URBAN DESIGN COMMISSION APPLICATION

SHEET LIST - ARCHITECTURAL	
SHEET NUMBER	SHEET NAME
PR0.0	COVERSHEET FOR PROPOSED CHANGES
PR1.1	BUILDING 1 & 2 PROPOSED CHANGES - FLOOR PLAN
PR1.2	BUILDING 1 & 2 PROPOSED CHANGES - ELEVATIONS
PR1.3	BUILDING 1 & 2 PROPOSED CHANGES - ELEVATIONS
PR1.4	BUILDING 1 & 2 PROPOSED CHANGES - ELEVATIONS
PR1.5	BUILDING 1 & 2 PROPOSED CHANGES - ELEVATIONS
PR1.6	BUILDING 1 & 2 PROPOSED CHANGES - ELEVATIONS
PR2.1	BUILDING 3 PROPOSED CHANGES - FLOOR PLAN
PR2.2	BUILDING 3 PROPOSED CHANGES - ELEVATIONS
PR2.3	BUILDING 3 PROPOSED CHANGES - ELEVATIONS
PR2.4	BUILDING 3 PROPOSED CHANGES - ELEVATIONS
PR3.1	BUILDING 4 PROPOSED CHANGES - FLOOR PLAN
PR3.2	BUILDING 4 PROPOSED CHANGES - ELEVATIONS
PR3.3	BUILDING 4 PROPOSED CHANGES - ELEVATIONS
PR3.4	BUILDING 4 PROPOSED CHANGES - ELEVATIONS
PR3.5	BUILDING 4 PROPOSED CHANGES - ELEVATIONS

MULTI-FAMILY HOUSING
THE MEADOWLANDS
MADISON, WI
KCG HOUSING DEVELOPMENT

THE MEADOWLANDS - PROPOSED SITE PLAN CHANGES

3 PARTIAL EAST ELEVATION - BLDG 1 - PROPOSED DESIGN
BUILDING 1 - ZONE B SHOWN
BUILDING 2 - ZONE D SIMILAR
PR1.4 1/8" = 1'-0"

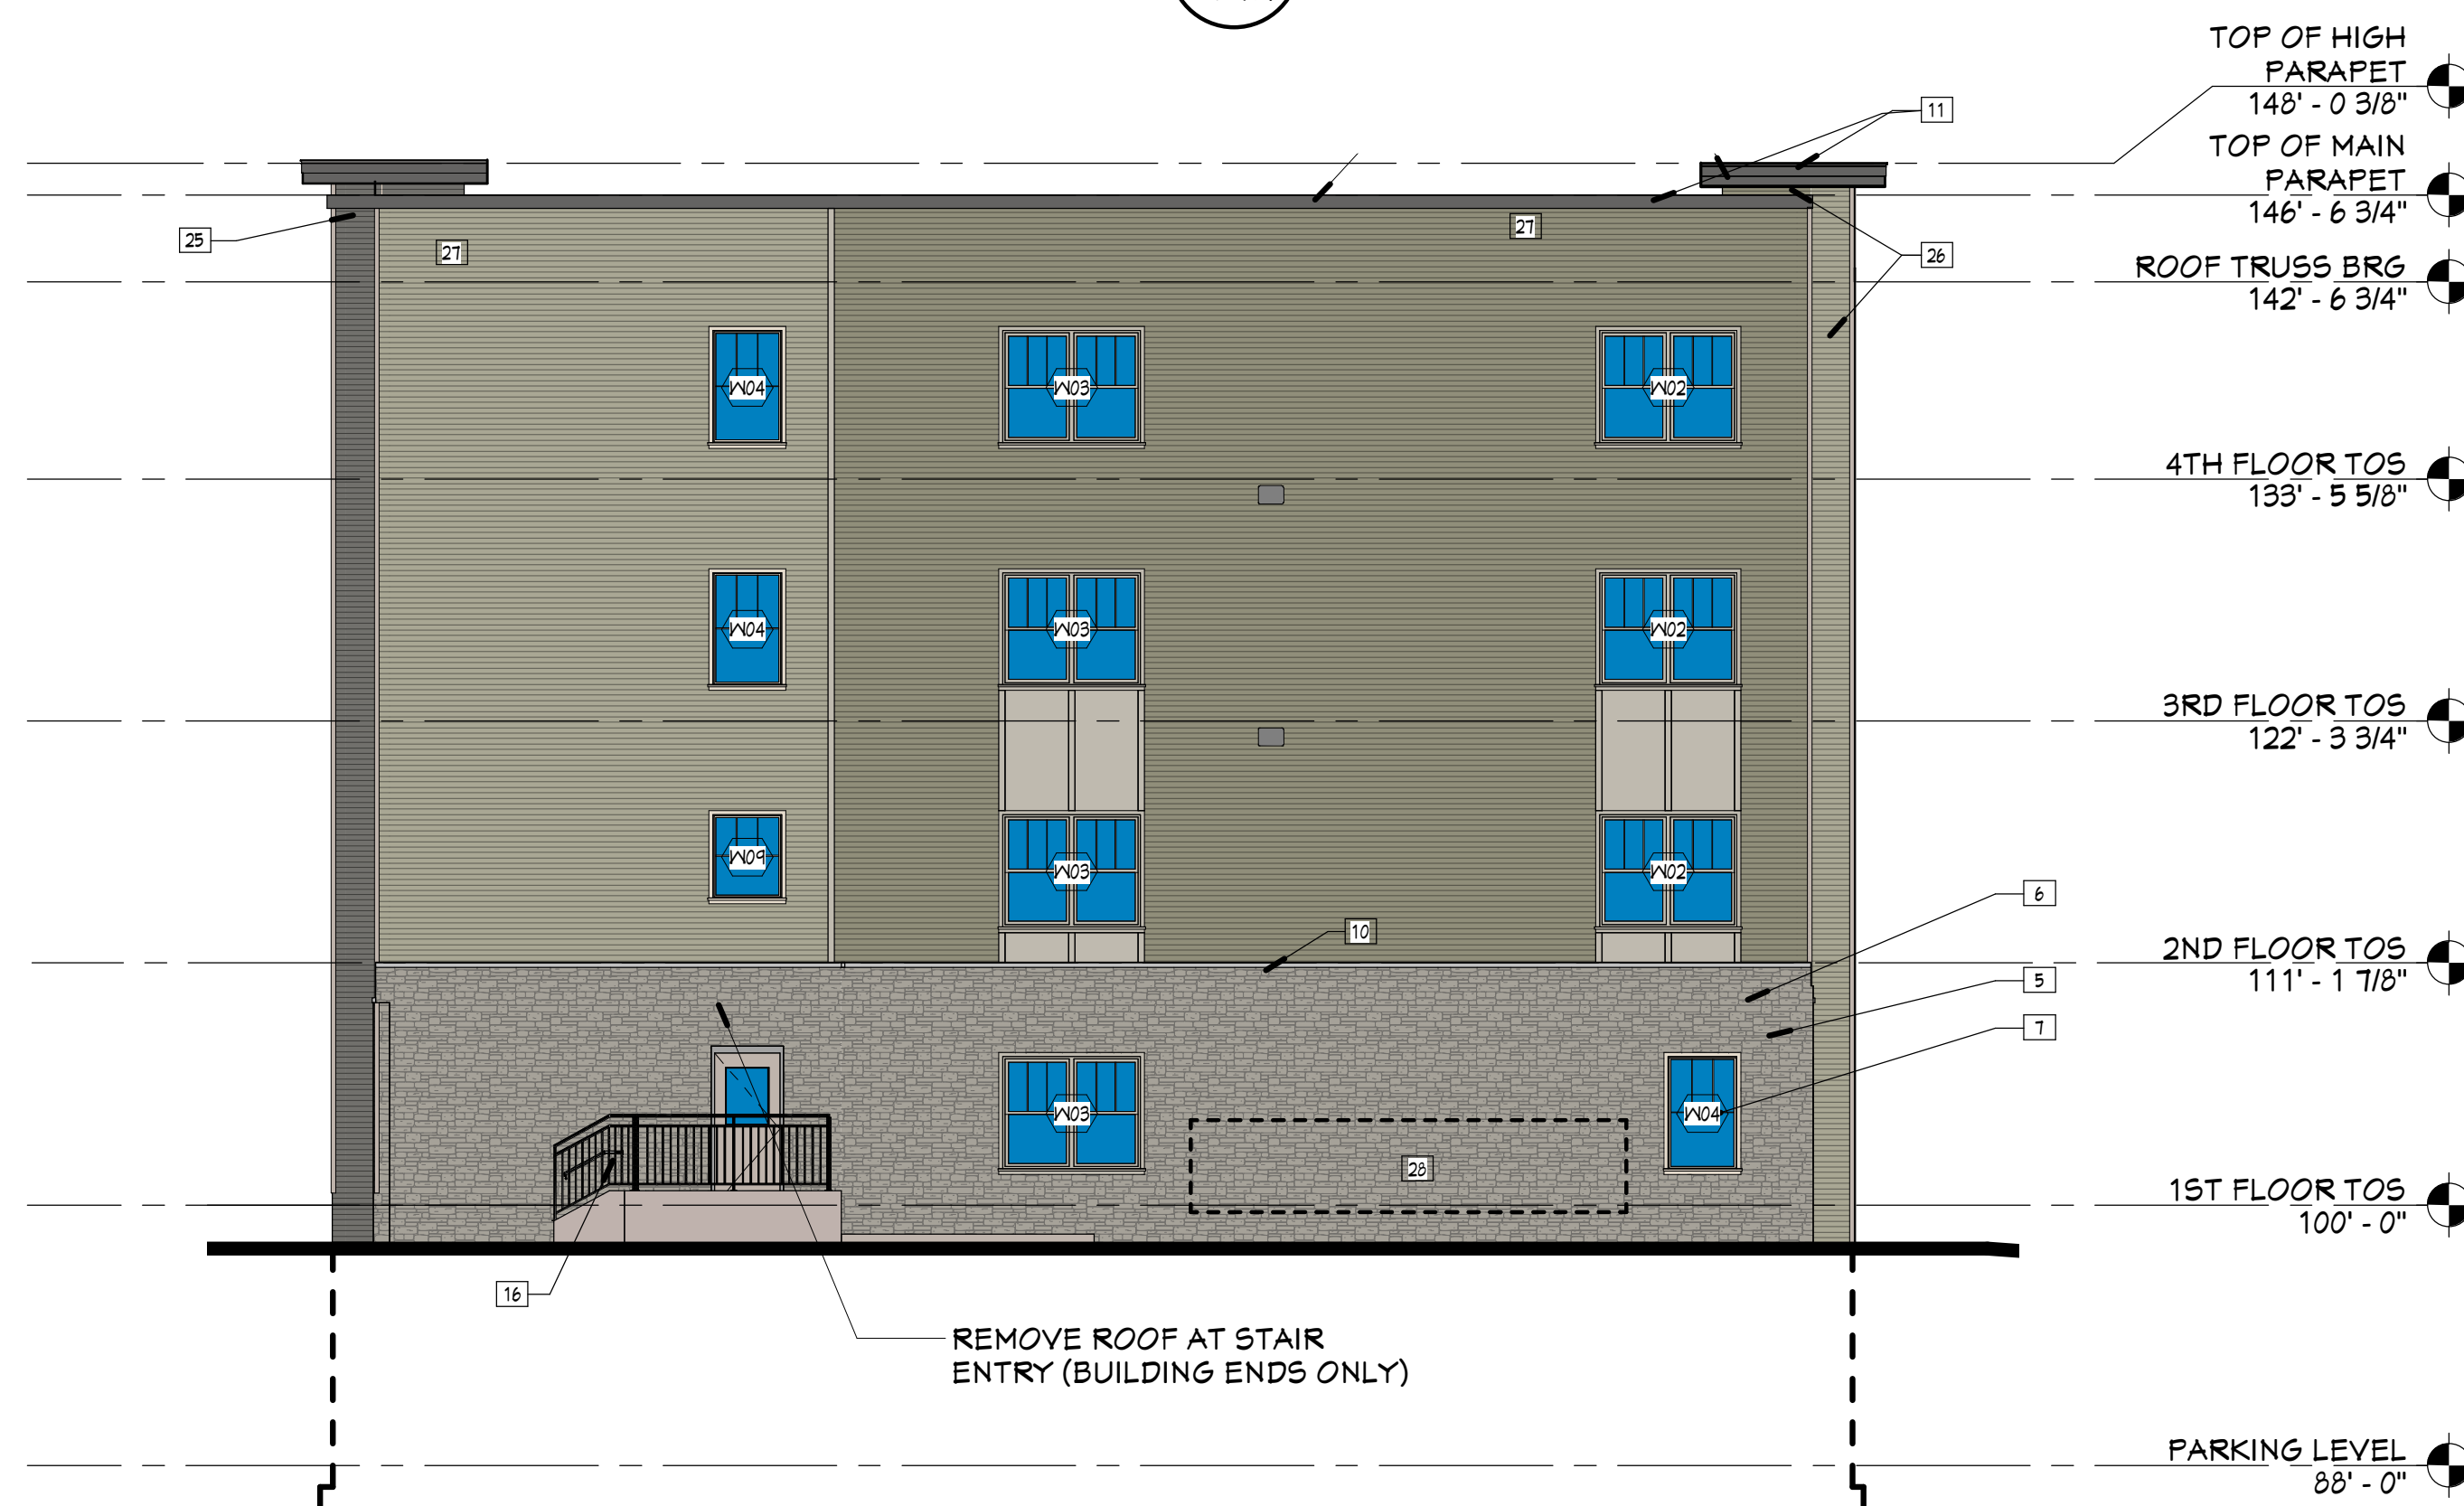
1. REMOVE STEPS TO FIRST FLOOR PRIVATE PATIOS AND ASSOCIATED RETAINING WALLS
2. DECORATIVE SCONCES REMOVED (LIGHTING PLACED IN SOFFIT ABOVE WHERE APPLICABLE)
3. REMOVE ROOF TO PORCH AT STAIR ENTRIES (TYPICAL OF ALL END BUILDINGS ENTRIES ONLY)

**BUILDING 3
PROPOSED
CHANGES - FLOOR
PLAN**

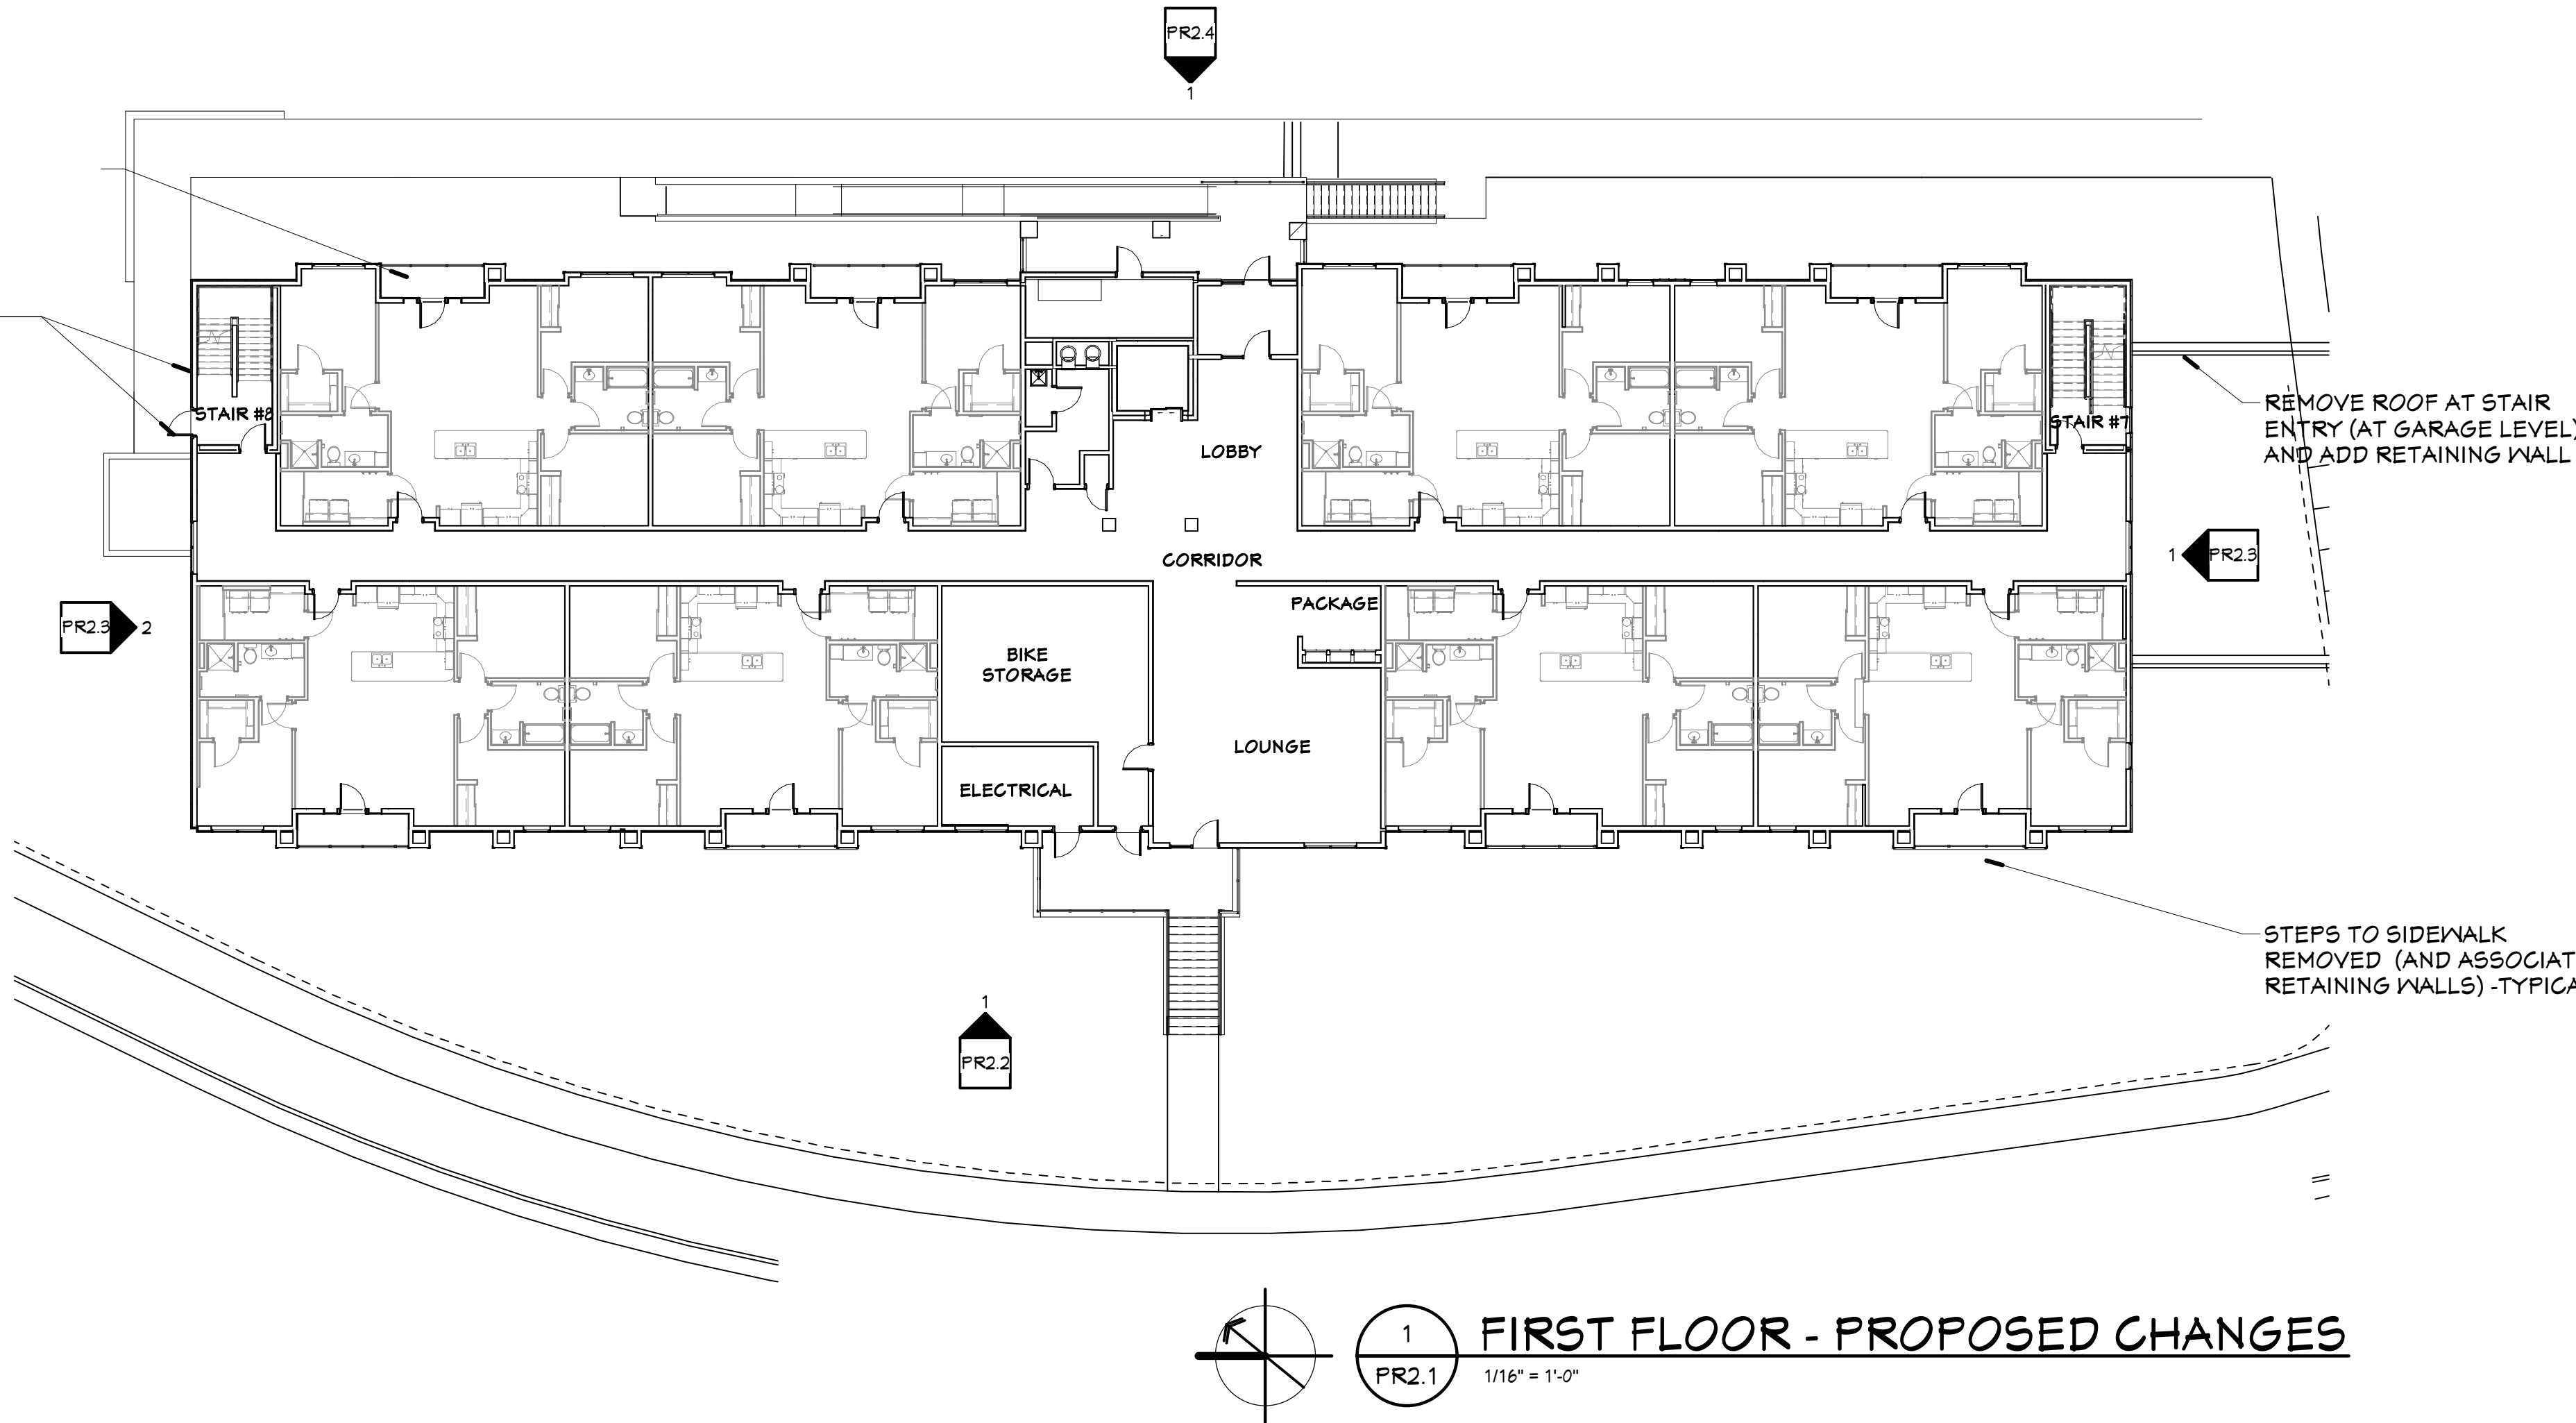
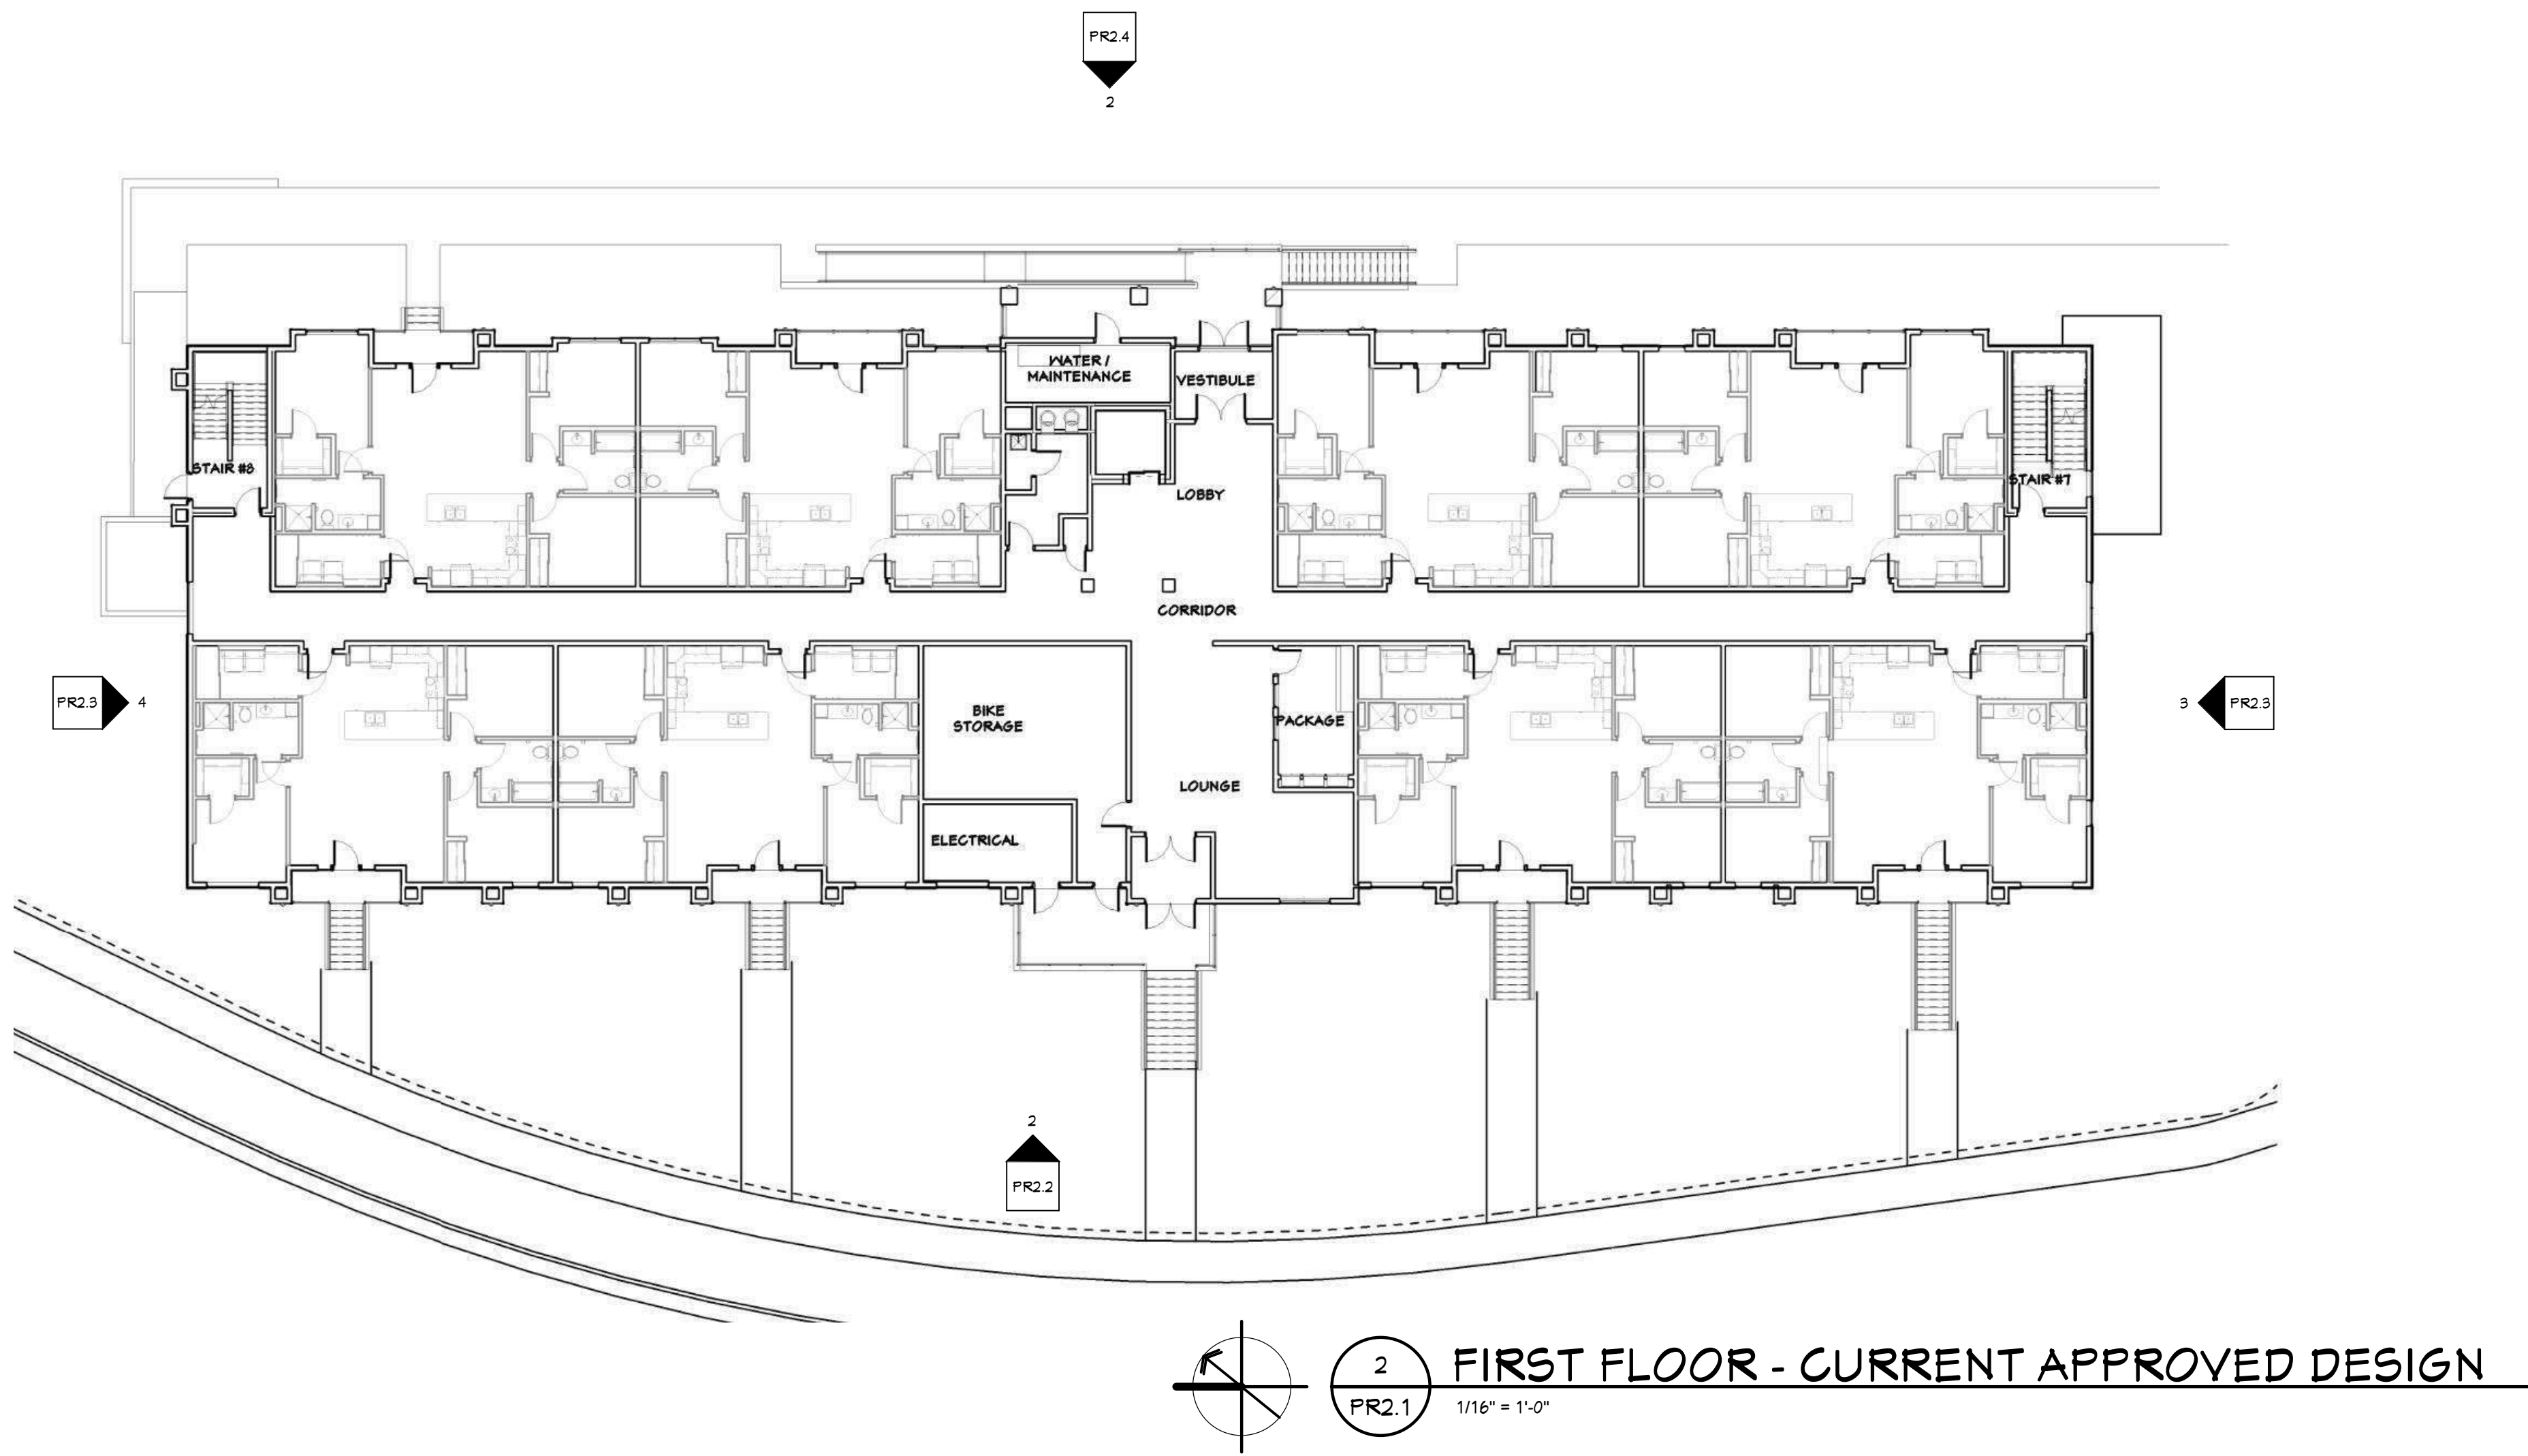
1. REMOVE STEPS TO FIRST FLOOR PRIVATE PATIOS AND ASSOCIATED SIDE WALKS & RETAINING WALLS
2. DECORATIVE SCONCES REMOVED (LIGHTING PLACED IN SOFFIT ABOVE WHERE APPLICABLE)
3. REMOVE ROOF TO PORCH AT STAIR ENTRIES (TYPICAL OF ALL END BUILDINGS ENTRIES ONLY)
4. REDUCE PORCH SIZE AT STAIR ENTRIES.
